## **REEVALUATION OF FINDING OF NO SIGNIFICANT IMPACT (FONSI)**

### **REVISED FINISHED WATERLINE INSTALLATION PLANS SEVIERVILLE WATER SYSTEMS (SWS) RAW WATER INTAKE AND WATER TREATMENT PLANT – FRENCH BROAD RIVER MILE 27.5L, SEVIER COUNTY, TENNESSEE**

**Jordan Jones and Goulding Request  
and Revised Plans of January 16, 2006**

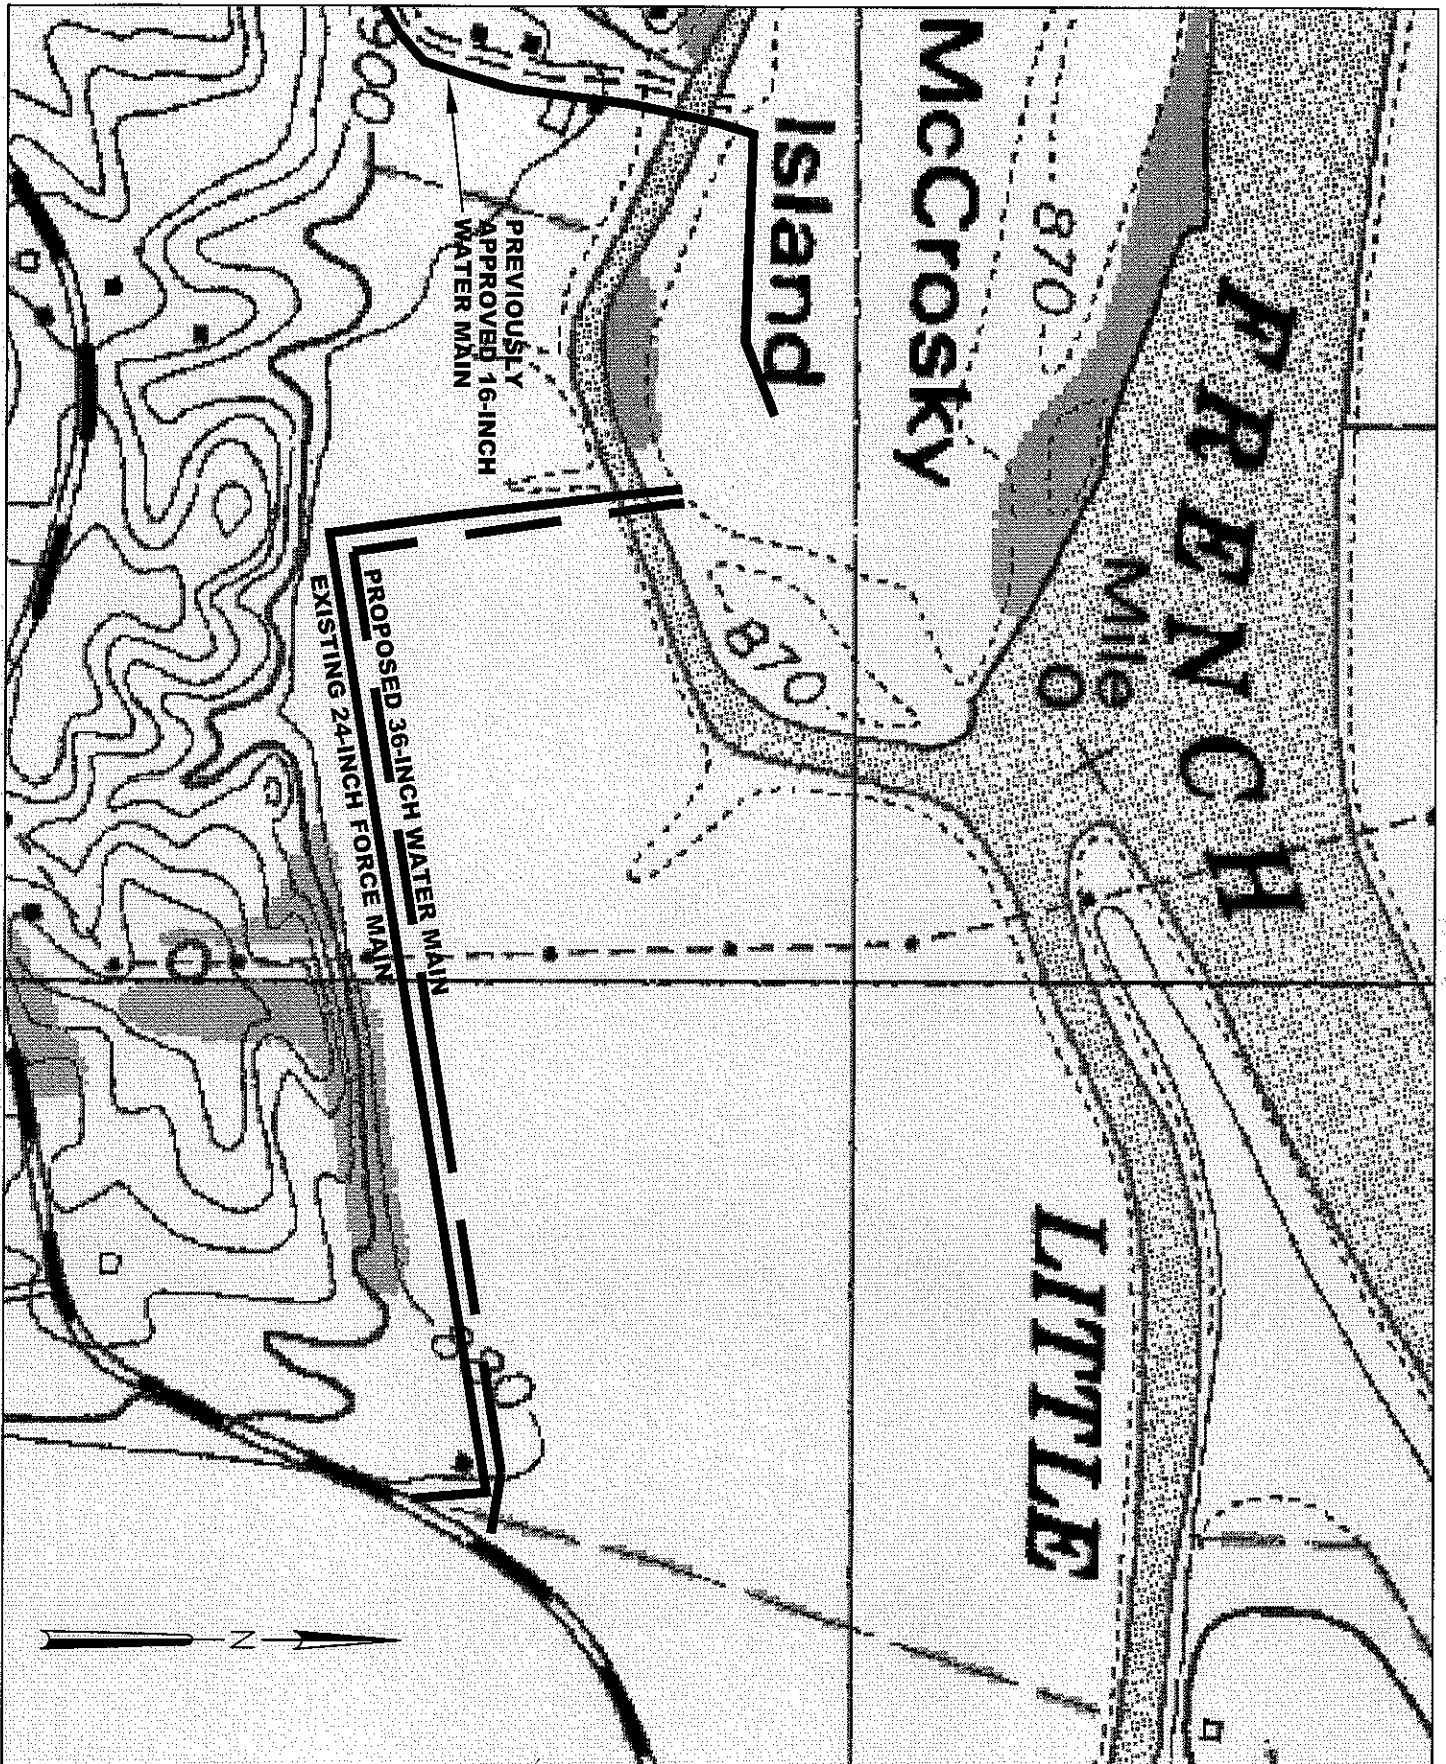
At this time we wish to request an amendment be made to the existing permit to allow this additional crossing. I am enclosing a plan view drawing of a USGS topographic map which shows the location of the additional water main crossing, the previously approved water main crossing and the existing waste water force main.

UTILITY PROFILE

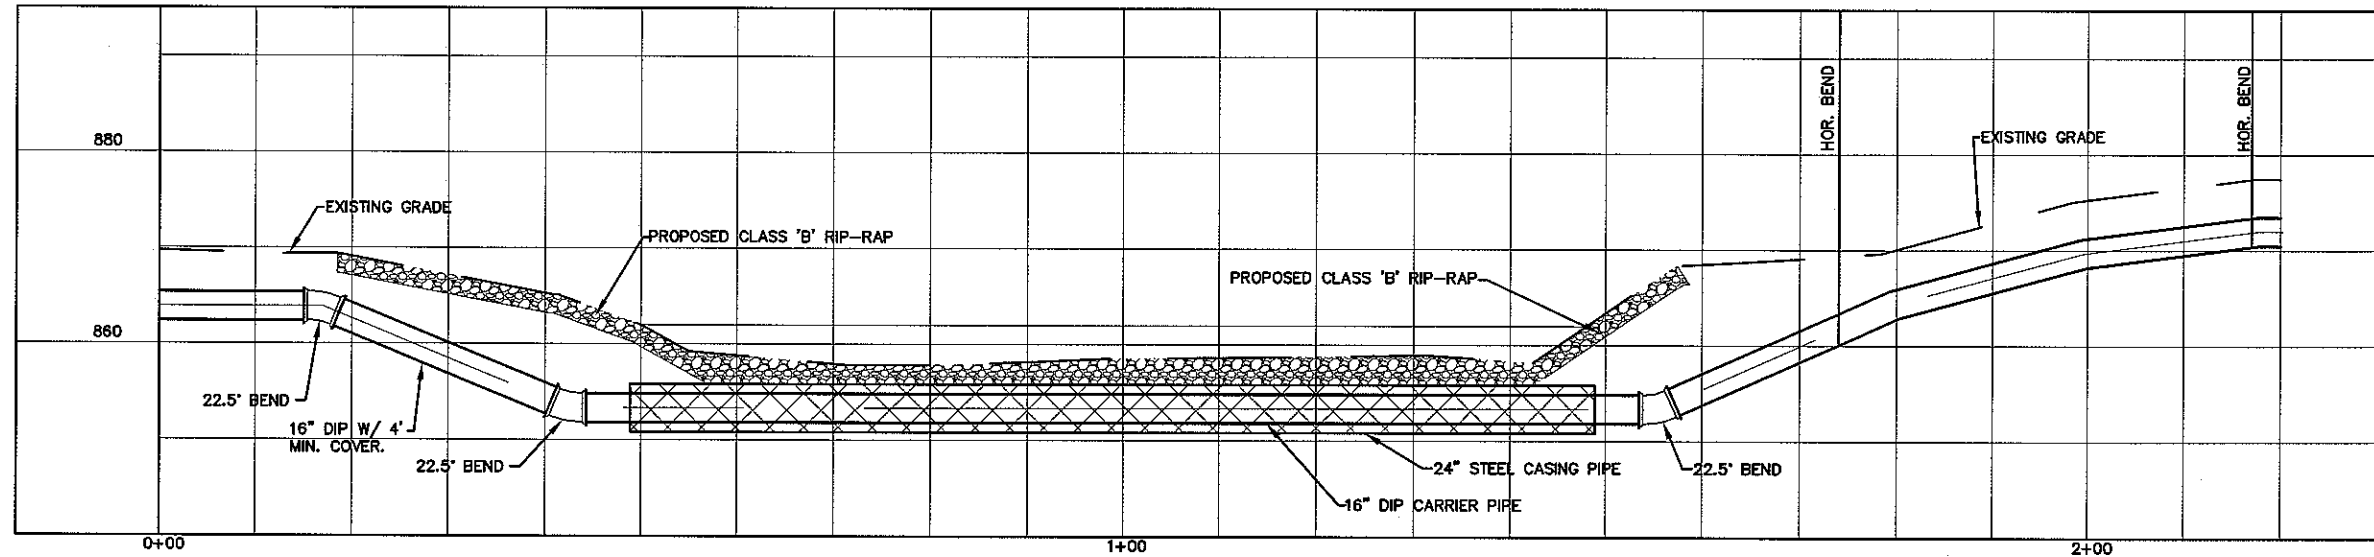
- Sheet CP1.0 - Plan View of 16-inch finished water main. This line was previously approved to be a 36-inch main.
- Sheet CP1.1 - Cross Sectional Detail of 16-inch water main crossing.
- Sheet CU1.6A - Plan View of all water main crossings. This includes the 16-inch and newly proposed 36-inch finished water mains, the 8-inch raw water main, and the existing 24-inch sewer force main.
- Sheet CU1.6A - Cross Sectional Detail of 36-inch water main crossing. The drawing also includes a plan view of the 36-inch finished water main and the 8-inch raw water main.
